KRG SUBMISSIONS SSD-101444458, Shop top housing with affordable housing - 810 Pacific Highway, Gordon

Thank you for the opportunity to comment on State Significant Development (SSD) application (SSD-101444458) for the proposed Shop Top Housing Development with in-fill affordable housing development at 810 Pacific Highway, Gordon.

Figure 3: Extract from Appendix O

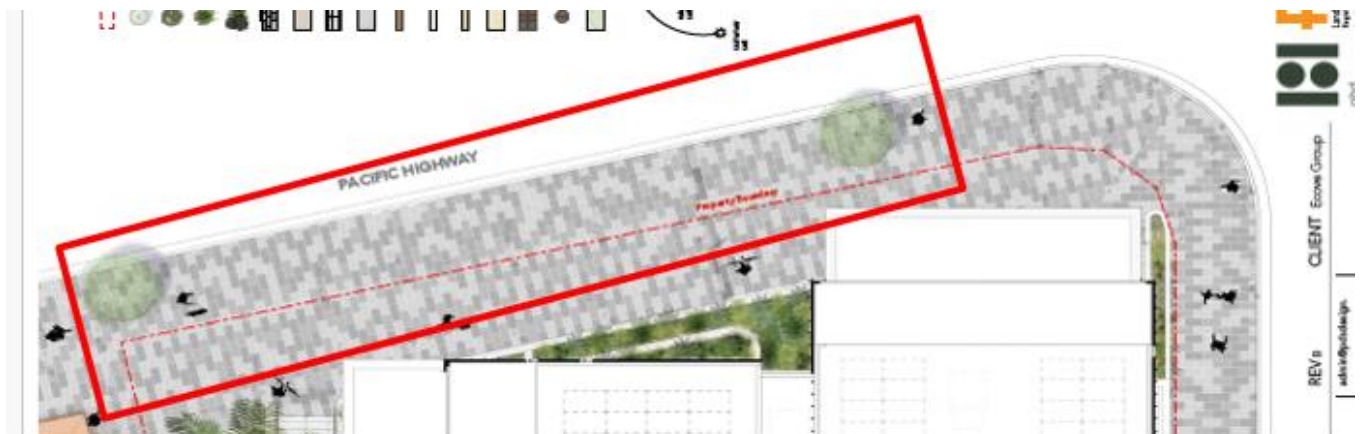
Further, it should be noted that the Landscape Package (Appendix O) indicates the retention of two existing Lagerstroemia's (Crepe Myrtle) along the Pacific Highway as shown below:

Prior to approval, the Landscape Package must be amended to incorporate these two street trees along the Pacific Highway.

Figure 4: Extract showing approved landscaping on Pacific Highway

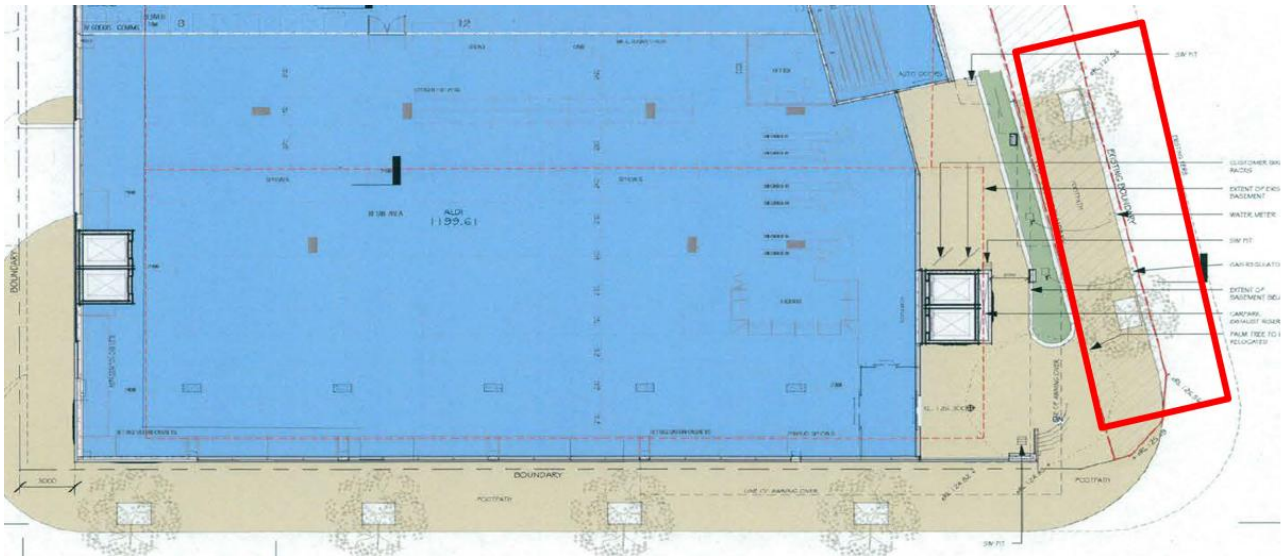
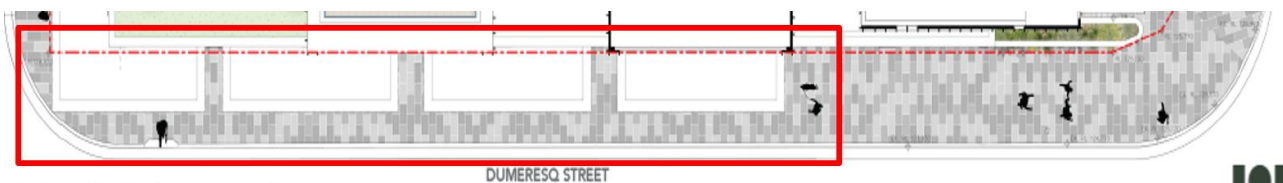
However, Condition 57 (Figure 4) included the requirement for two street trees (*Pyrus calleryana* 'Capital') to be planted to the street frontage with consideration for the future Transport for NSW kerb realignment. It is recommended that these trees be planted at a minimum 200L pot size.

Figure 6: Extract showing approved public domain outcome

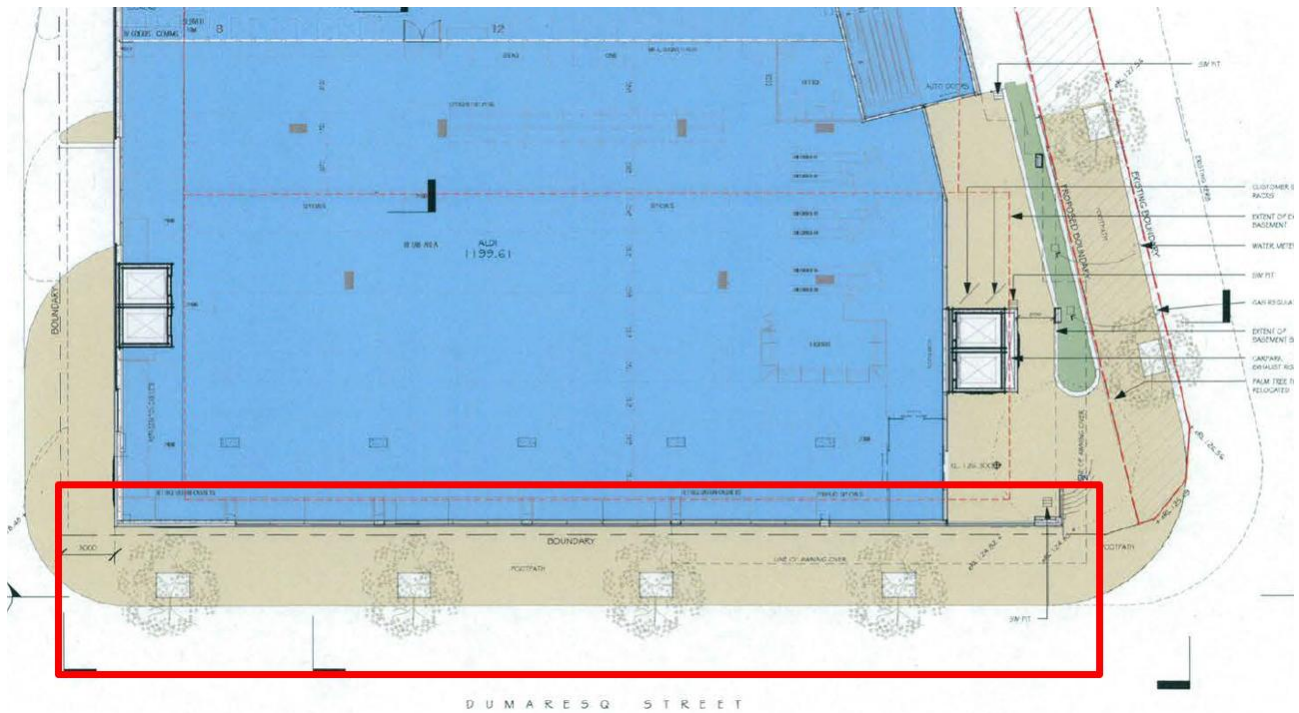
The stamped approved plans for this site (Figure 6), however, indicated narrower continuous awnings along the Dumaresq Street frontage with the provision of four street trees. Clause 57 of the current Notice of Determination clearly indicated the requirement for four street trees (*Pyrus calleryana* 'Capital') to be planted along this street frontage. It is recommended that these trees be planted at a minimum 200L pot size.

Prior to approval, the Landscape Package (and associated Architectural Drawings) must be amended to incorporate these four street trees with awnings designed to enable the successful growth and canopy spread of the street trees.

Figure 9: Markup showing blank wall and inactive frontage

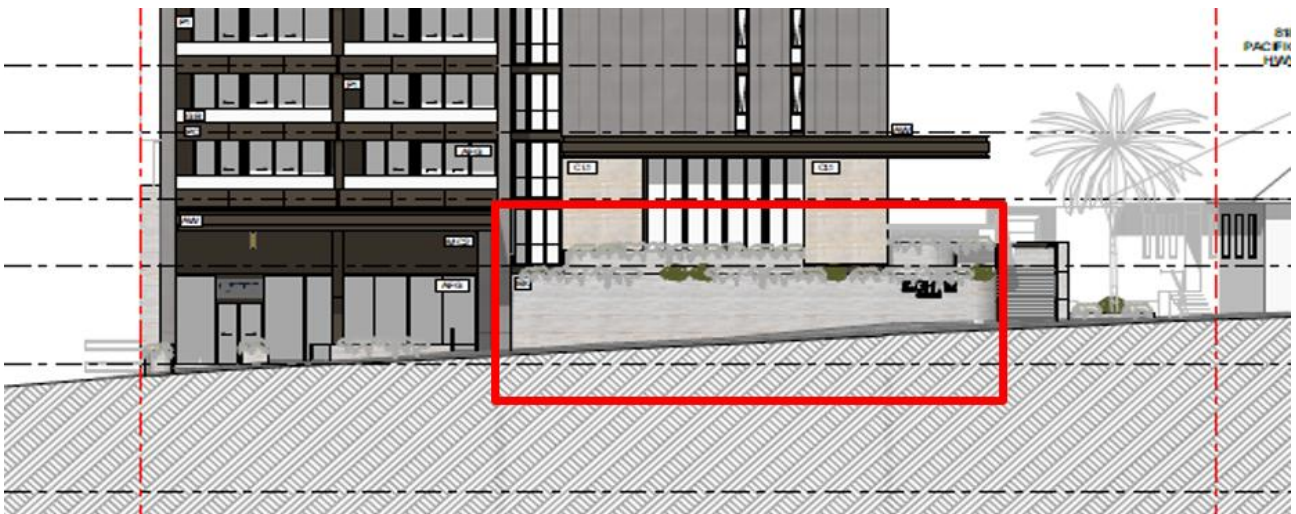
The Pacific Highway is identified as a Principal Active Frontage under 14D.5 Built Form. With respect to the Principal Active Frontage along the Pacific Highway, it should be noted that Aldi is the only active frontage provided along the Pacific Highway. Approximately half of the street frontage at street levels is dominated by a 2-3m high flat retaining wall (Figure 9) that does little to activate the street frontage or improve the amenity of the public domain.

It is recommended that this flat wall is designed with improved consideration for the interface between the development and the public domain along the Pacific Highway. There are several other exposed flat perimeter walls. The applicant is encouraged to reconsider treatment of this place making outcomes such as public art.

Figure 10: Mark up showing Boundary tapering

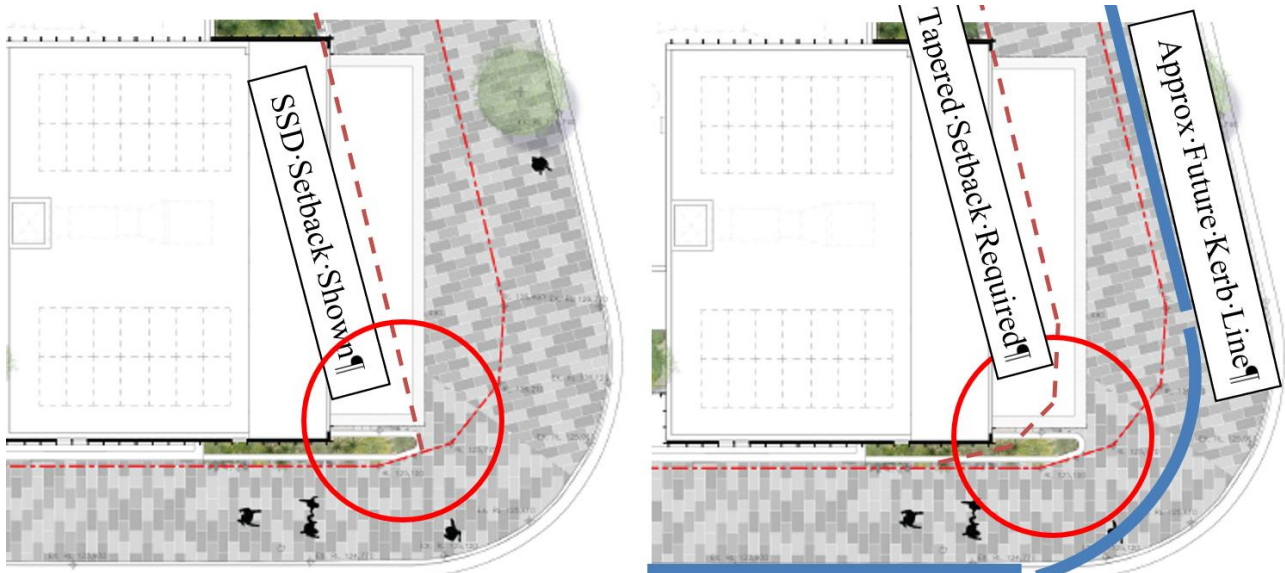
The 4m setback along the Pacific Highway as shown in the Landscape Package does not follow the tapering of the property boundary at the corner of Dumaresq Street (DWG NO LA-3) **Figure 10**: Council's traffic assessment suggests that the 4m setback follows the line of the tapering at the intersection as shown below (Figure 11).

As such, the building and awning encroach upon the width of the future footpath required at this intersection. The encroachment will create unacceptable limitations to the future design and location of traffic infrastructure such as traffic signals and public domain infrastructure such as pram ramps. Prior to approval, the Landscape Package (and associated Architectural Drawings) must be amended to prevent encroachment into the future footpath and road widening area.

Figure 13: Mark up of where retail parking can be located

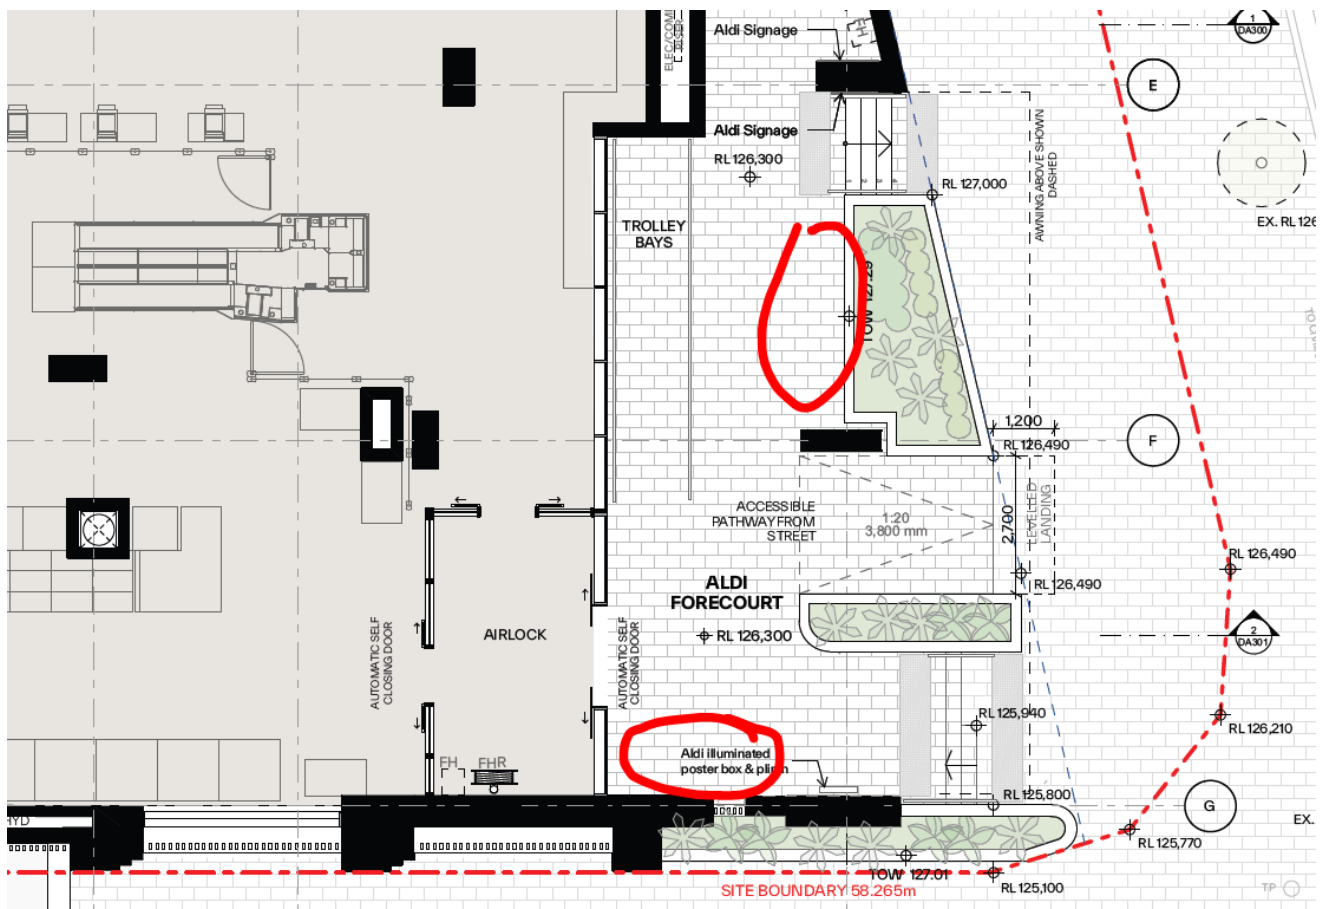
The retail customer bicycle parking is shown as shared with the retail staff bicycle parking on Basement Level 1, but the 2 security levels required for the different users are incompatible. Retail customer bicycle parking should be relocated to street level, somewhere near the main pedestrian entrance on the Pacific Highway frontage:

Figure 14: Mark up of area to be removed.

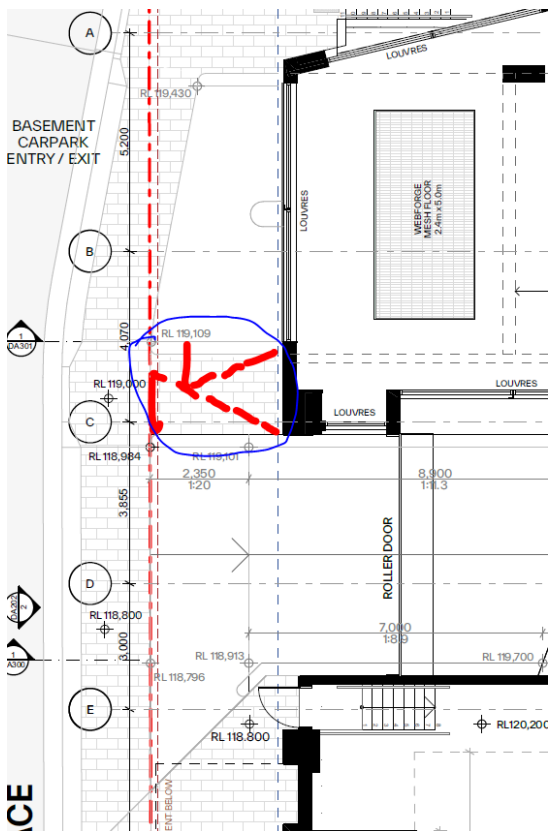
If the paved area between the retail/residential access point and the loading dock access point is required for compliance in the provision of the relevant sight triangles as per AS2890.1 and AS2890.2, then the paving between the 2 driveways should be removed (circled in blue below) and replaced with the same material as the driveways to distinguish this area as separate from the footpath area.
